## LINCOLN CITY/LANCASTER COUNTY PLANNING STAFF REPORT

-----  
for May 14, 2003 PLANNING COMMISSION MEETING

**P.A.S.:** Special Permit 421D  
Carriage Hill 4<sup>th</sup> Addition CUP

**PROPOSAL:** Amend the Carriage Hill CUP to retain the existing single family dwelling and allow the construction of four two-family structures, and the extension of an existing private driveway, private sanitary sewer, and public water main to serve these units.

## PROPOSED SITE PLAN

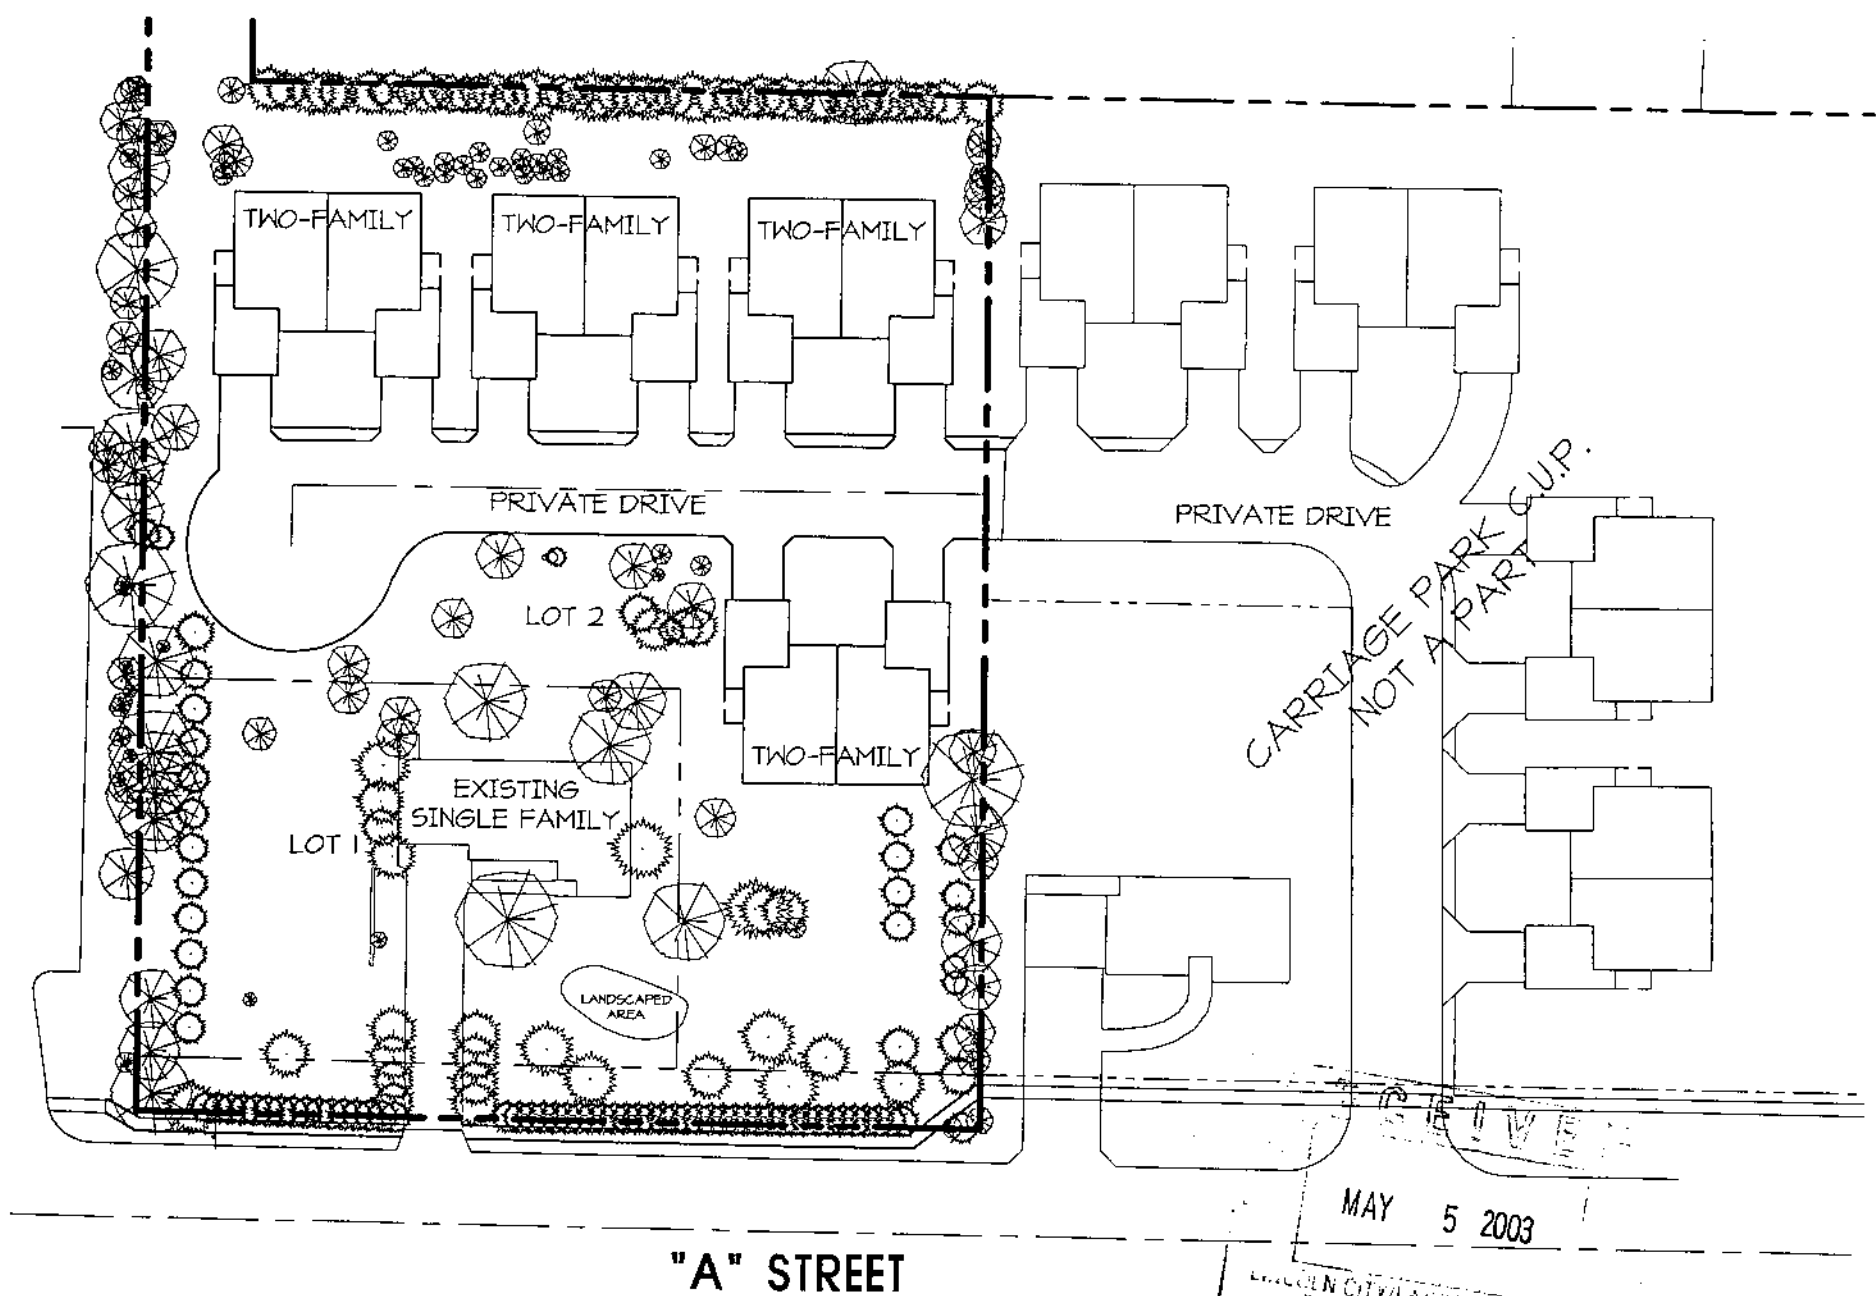
- Show the required 30' easement for the proposed 6" public water main.
- The existing fence shown on the plans to remain in the right of way needs to be removed or relocated outside of the public right of way.

- The existing trees along A Street are not appropriate for the public right of way. Public Works recommends that the right of way be graded to match City of Lincoln Standards and the sidewalk to be located the standard distance from the right of way line.

- The low point in the private drive in the existing development to the east of this project appears to have no safe overflow route to the detention pond located further to the east. It appears that the garage openings to the adjacent dwellings are very close, if not equal to the elevation of the flow path. Adding the additional drainage from the proposed development will compound this potential problem.

- The letter states that the site will be graded to drain to the east along the private driveway and that modifications are proposed to the existing storm system in the development to the east. The grading plan needs to be revised to show that the units on the north side of the proposed private drive will drain to the drive. Also, the proposed changes to the storm system need to be shown and/or clearly described.

- A note needs to be added stating that any future subdivision of Lot 1 will require the owner to relinquish access to A Street and take access via the proposed private drive.

- 1.1 Revise the site plan to show:
    - 1.1.1 The proposed two family dwellings with the same setback as the existing Carriage park dwellings.
    - 1.1.2 The required 30' easement for the proposed 6" public water main.

- 1.1.3 The existing fence shown on the plans to remain in the right-of-way needs to be removed or relocated outside of the public right-of-way.
    - 1.1.4 The right-of-way graded to match City of Lincoln standards and the sidewalk located the standard distance from the right-of-way line.

- 1.1.5 A note stating that any future subdivision of Lot 1 will require the owner to relinquish access to "A" Street and take access via the proposed private drive.

- 1.2 Revise the grading plan to the satisfaction of Public Works & Utilities that:
    - 1.2.1 Addresses the need for an overflow route from the private drive in the existing development to the detention pond to the east.

- 1.2.2 Shows the minimum opening elevations adjacent to the flow path meet minimum design standards.
    - 1.2.3 Shows the units to the north side of the proposed private drive will drain to the drive.

- 1.2.4 Shows and clearly describes the proposed changes to the storm system.
  - 1.3 Submit documentation that demonstrates the Carriage Hill Homeowner's Association is satisfied that this development will not intensify or further increase the drainage problems they currently experience.
